Date of Issue: July 22, 2025**SI-23****Project:** Saverino Phase 1
556-560 Essa Road
Barrie ON L4N 9E6**Project No.:** 22-6229**Permit Number:** PMT20-01273**Prime Consultant:** McKnight Charron Limited (MCL) Architects**General Contractor:** Van Horne Construction Limited**Title:** *Parking Level Drainage Revision*

The following modifications are noted on attached drawings under revision number 17.

1 PARKING PLAN PLUMBING & DRAINAGE LAYOUT
Scale: 1:100

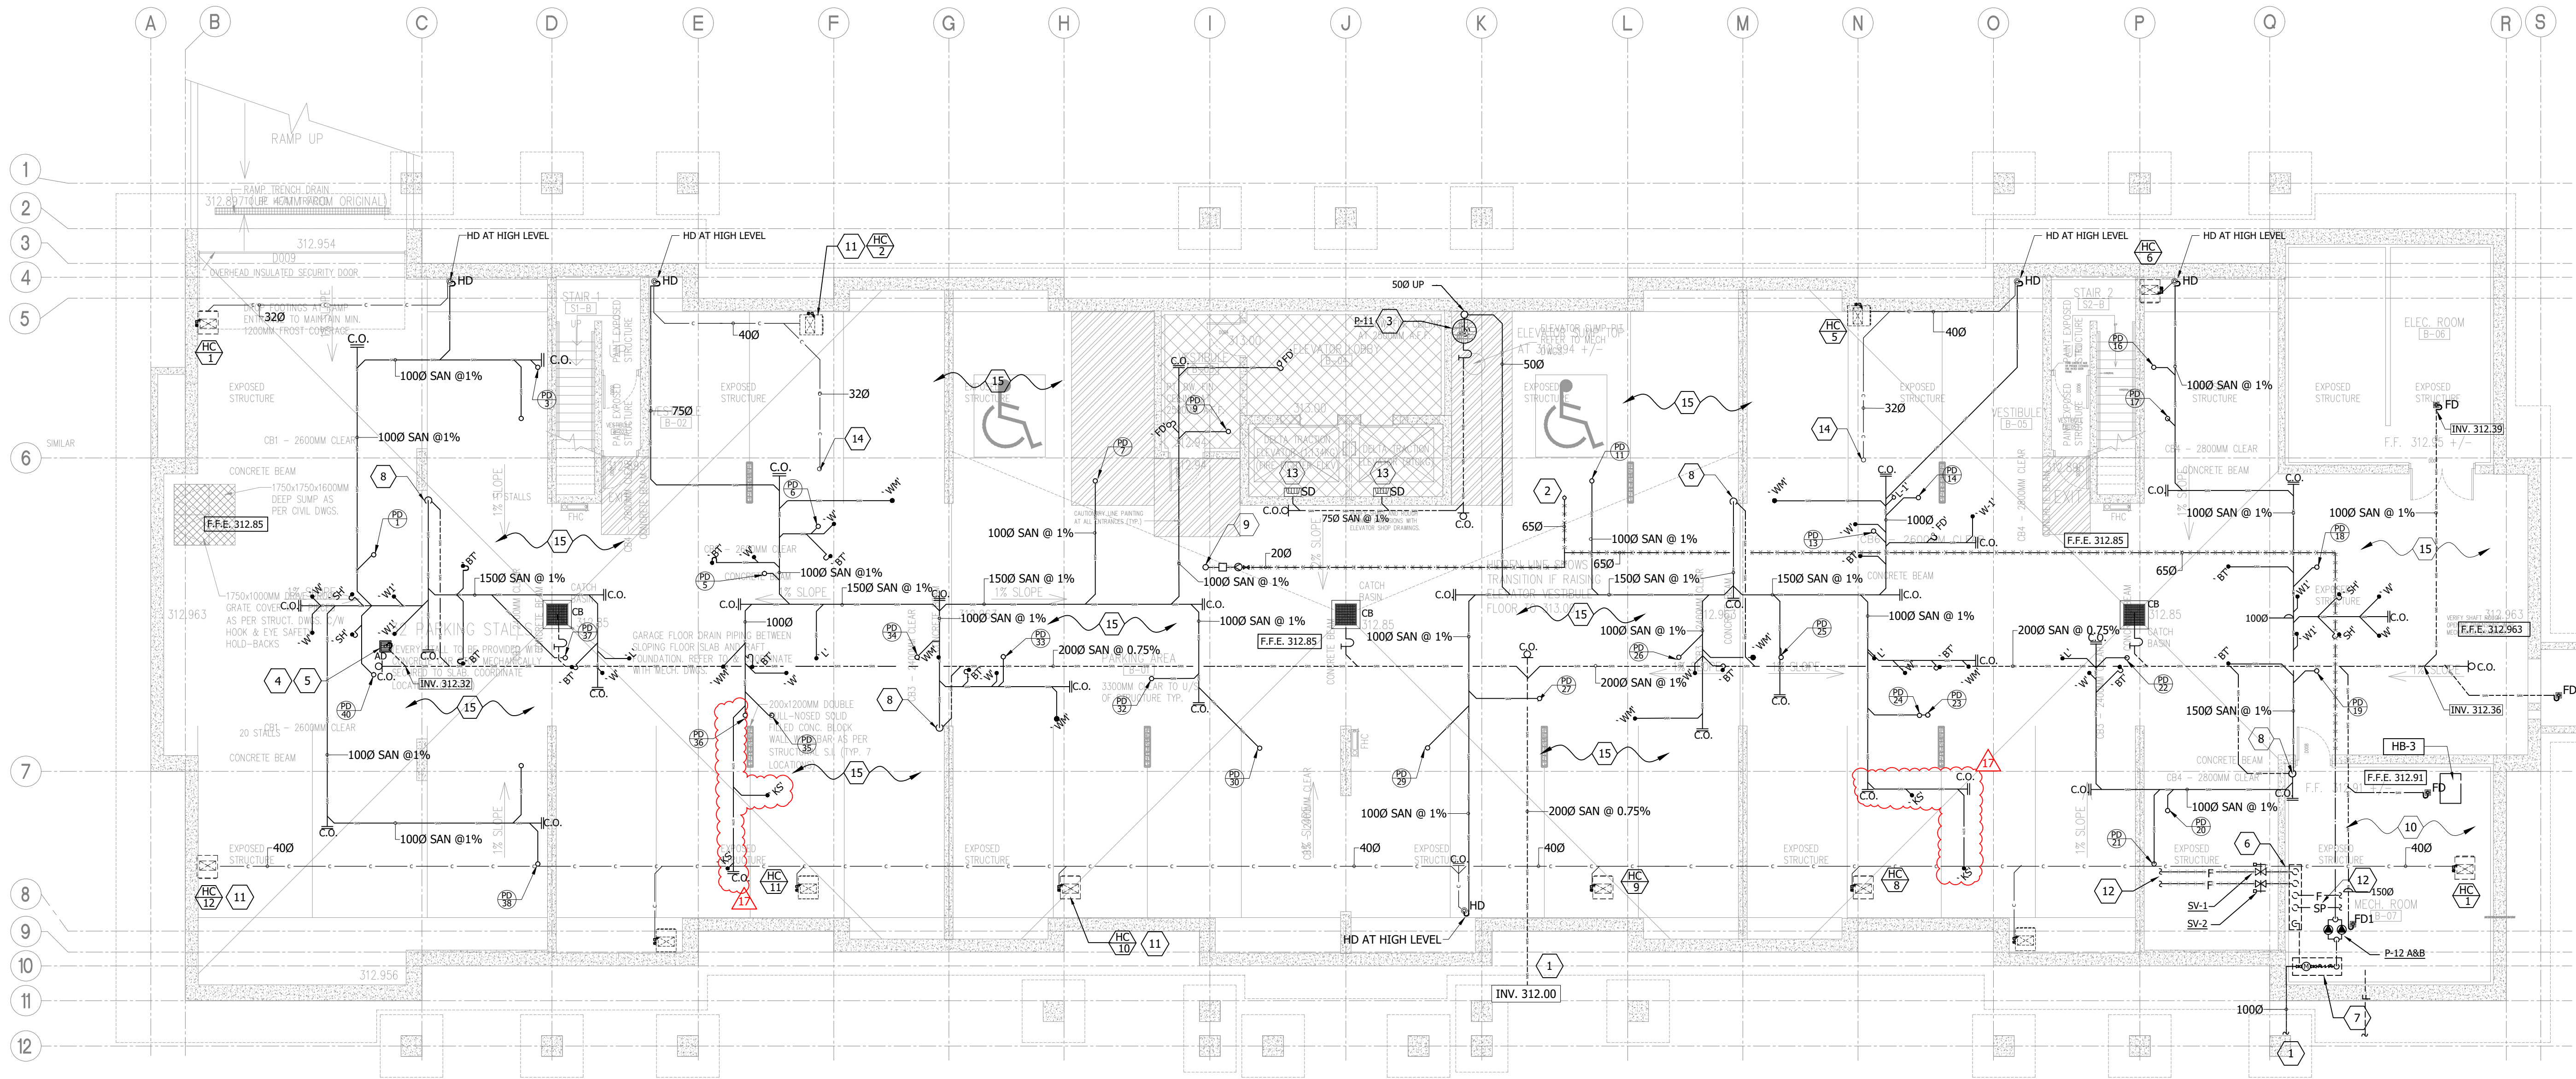
1. Install drainage pipes for fixtures from ground floor and connect to main sanitary pipe as shown on drawings PD-102.
